WORKING DRAFT OF NEC® CODE MAKING PANEL 2 MEETING OUTPUT

Document: National Electrical Code®

Revision Cycle: A2019

Committee Activity: Comment Stage

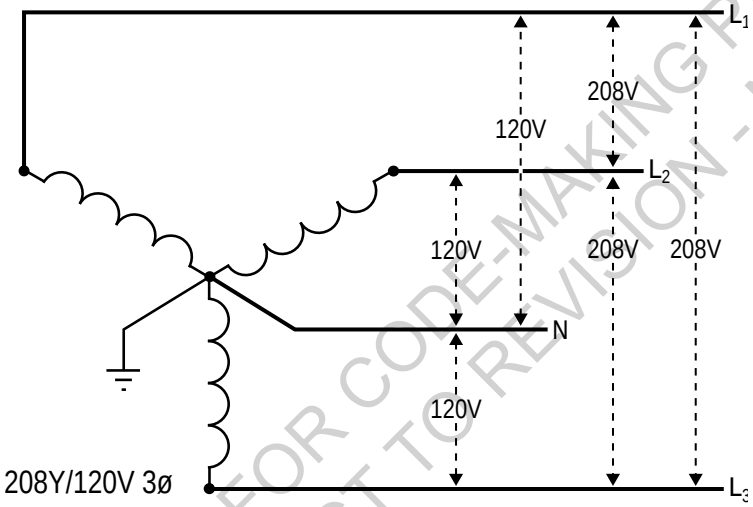
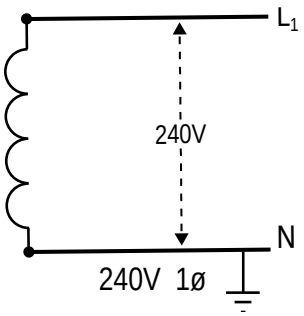
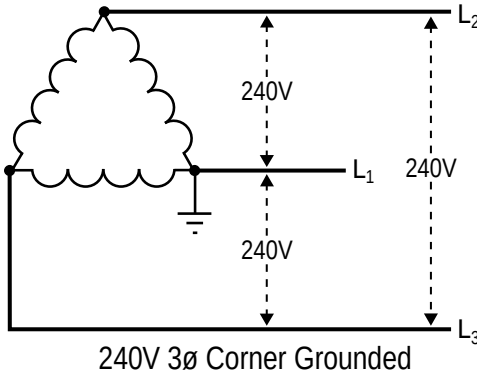
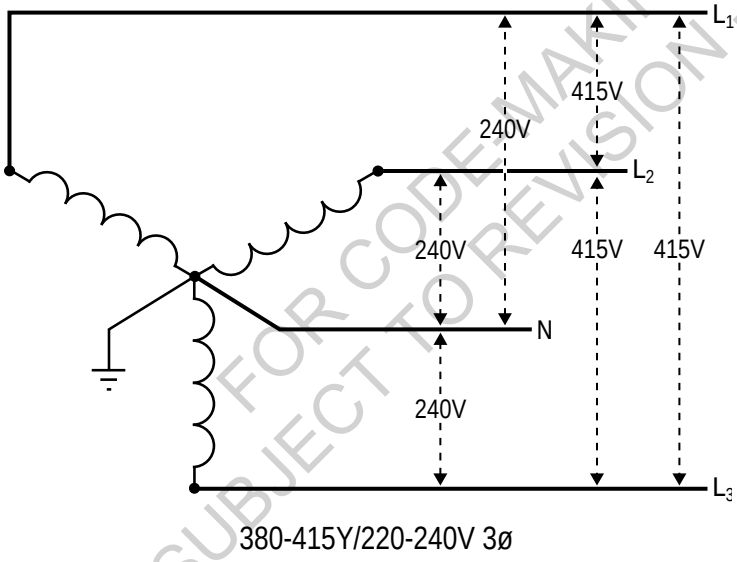
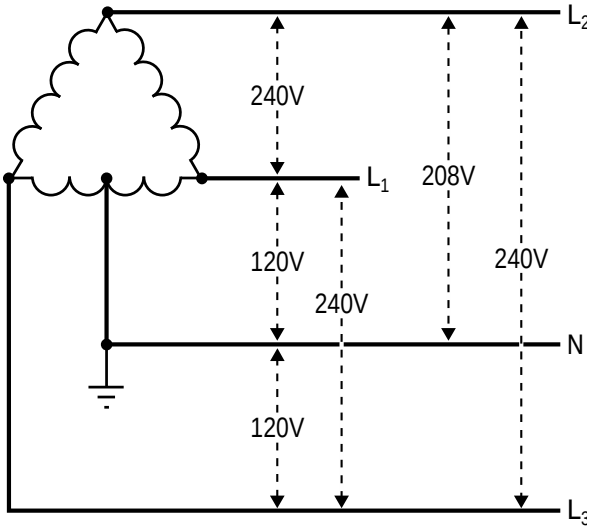
To replace the single-phase branch circuit rating of “150 volts or less to ground” with “125 volt through 250 volt”, however, would negate that parallel specification with 210.8(A).

Class A GFCI protection applies to 150 volts or less to ground. Receptacles (single-phase) rated as 250-volts, in accordance with UL’s Listing Guide Information RTRT can be connected to branch and motor circuits providing 240 volts or 208 volts, single-phase.

Some services providing 240 volts or 208 volts, single-phase, do so without exceeding GFCI Class A’s limit of 150 volts to ground, and are suitable for Class A GFCI protection at a receptacle rated as 250-volts. These include:

By contrast, some services providing 240 volts or 208 volts, single-phase, do so exceeding GFCI Class A’s limit of 150 volts to ground, and are not suitable for Class A GFCI protection at a receptacle rated as 250-volts. These include:

Finally, one service provides 240 volts and 208 volts, single-phase, does so exceeding GFCI Class A's limit of 150 volts to ground on the high leg (required to be colored orange per 110.15), and is not suitable for Class A GFCI protection at a receptacle rated as 250-volts,

but is within exceeding GFCI Class A's limit of 150 volts to ground on the "low" legs, and is suitable for Class A GFCI protection at a receptacle rated as 250-volts:

Figure 210.52(C)(1) Determination of Area Behind a Range, Counter-Mounted Cooking Unit, or Sink.

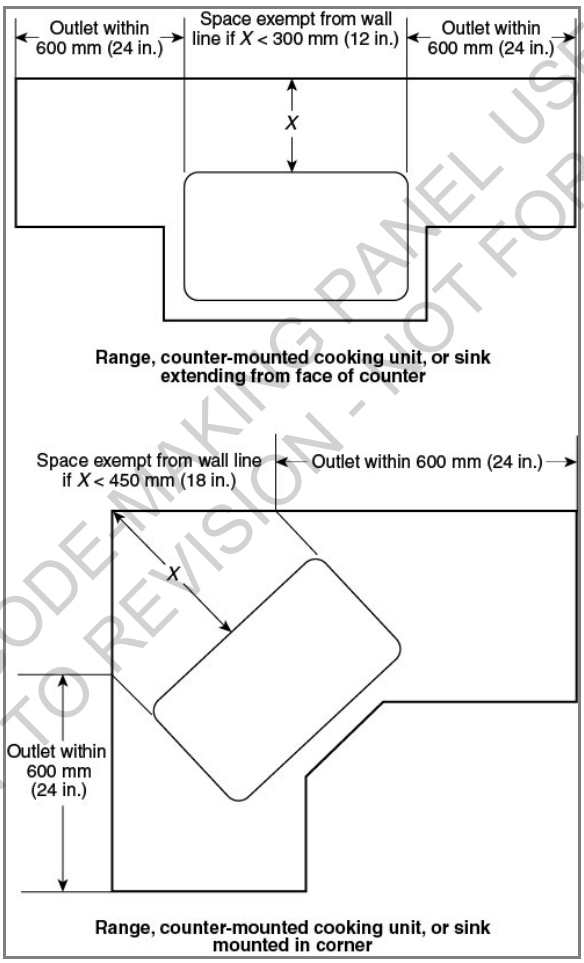
Exception: Receptacle outlets shall not be required directly behind a range, counter-mounted cooking unit, or sink in the installation described in Figure 210.52(C)(1) .

Response Message: SR-7644-NFPA 70-2018 RESPONSE TO PC 419: The proposed text for the rewording of the exception does not add clarity or usability. Adding “readily accessible” as proposed changes the intended requirement so the original language was retained. RESPONSE TO PC 1893 and 1418: The wording “without permanent seating” was not included as there may be different interpretations of what “permanent seating” is. The requirement for the receptacle outlet where the seating arrangement was over 1.8 m (6 ft) was not included as the same complications exist with countertops or work surfaces installed for seating purposes regardless of the length. Also, the presence of chairs around a fixed countertop or work surface does not preclude the use of power at those areas for kitchen or other appliances. Unlike a table that can be moved closer to a receptacle outlet, fixed countertops and work surfaces do not provide that flexibility, thus the use of extension cords becomes the only option to provide power at those areas. The 18 sq. ft. calculation in addition to the flexibility of locating the receptacle outlets address the concerns about seating. RESPONSE TO PC 494: The wording permitting the receptacle outlet installed for a countertop wall space to apply for the peninsular countertop was not included as the changes are intended to require a receptacle outlet to be installed in accordance with 210.52(C)(3) at the outer edge of the peninsular countertops. RESPONSE TO PC 680: The 600 mm (24 in.) was retained as it is the well understood long standing requirement.
